SUPPLEMENTAL INFORMATION

REQUESTED DURING THE
MAY 3, 2018 JOINT MEASURES C and EE BOND OVERSIGHT COMMITTEE MEETING

During the May 3, 2018 meeting, the BOC requested clarification or information on the following aspects of the Mira Costa Athletic Complex project (Measure EE). Responses below are consolidated from Gensler, Balfour-Beatty, and the District.

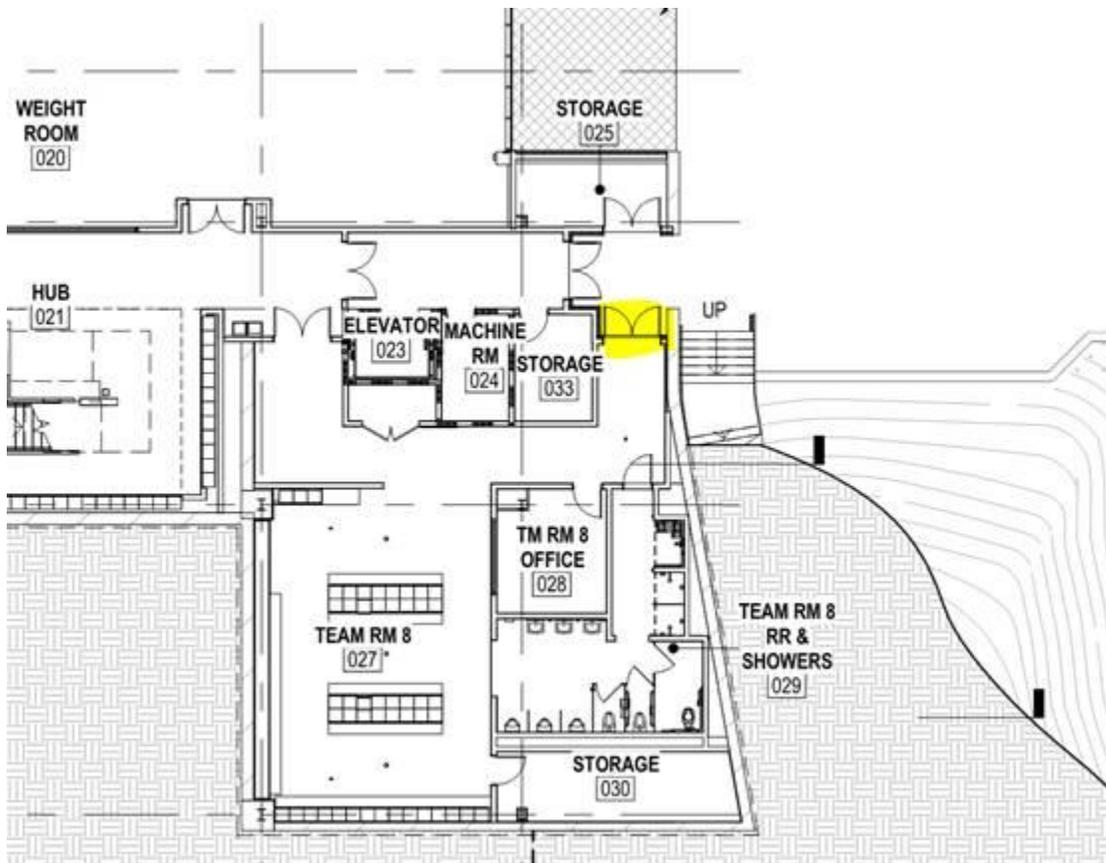
Q-2: Is the plan still to create some kind of path that will allow the football team to run out from the locker room onto the field?

The path would be through the lower level corridor, through the double exit doors. At this point they will be a few feet from the track. The football team also has direct exterior access through the double doors highlighted below.
